CONSERVATION TEAM CONSULTATION APPLICATION RESPONSE

APPLICATION REF:	25/02096/FPH & 25/02097/LBC
CASE OFFICER:	AHD
APPLICATION SITE:	Friends Green Farm, Friends Green, Damask Green Road, Weston, Hitchin, Hertfordshire, SG4 7BU
DESCRIPTION OF WORKS:	<i>Single storey side extension with glazed link to main dwelling and erection of single storey side porch, and re-opening of original window openings following demolition of existing side extension. Remove existing render and repair/re-pointing of existing brickwork with lime mortar and render.</i> <i>Single storey side extension with glazed link to main dwelling and erection of single storey side porch, and re-opening of original window openings following demolition of existing extension. Remove existing render and repair/re-pointing of existing brickwork with lime mortar and render. Internal alterations including new stairs to existing loft and relocation of kitchen, utility, and WC.</i>

- 1178.06A Pr FF
- 1178.08A Pr Sf
- 1178.11A Loft Staircase

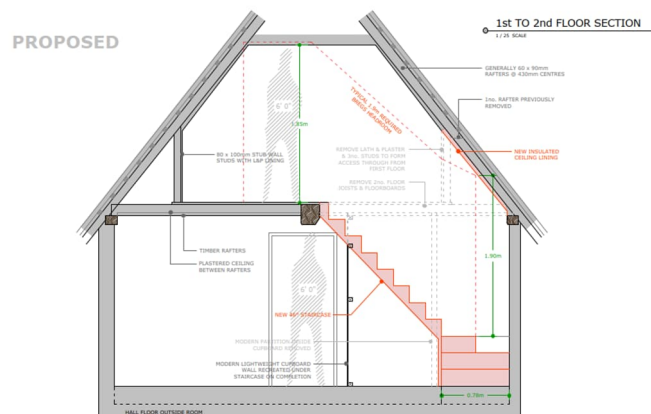
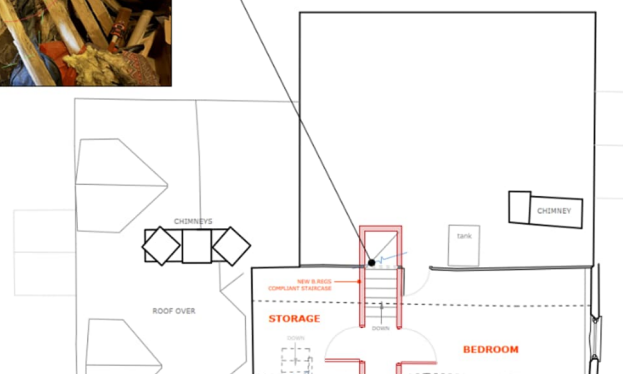
The drawing extracts below now illustrate precisely how the fabric will be affected by this part of the proposal. It appears that two joists would be removed together with either two or three studs (11A says 3no. whereas 08A says 2no.). Normally, I would be resisting the loss of historic fabric unless there is a convincing justification for doing so. On this occasion, the frame members are not considered to be of high significance and I am unaware of any carpentry markings. The joists to be removed do not currently present in the bedroom as they are concealed within two modern cupboard spaces and the remaining ceiling joists are complete ensuring that the character of this room is not unduly affected. The staircase would serve to make optimal use of some of the attic space.
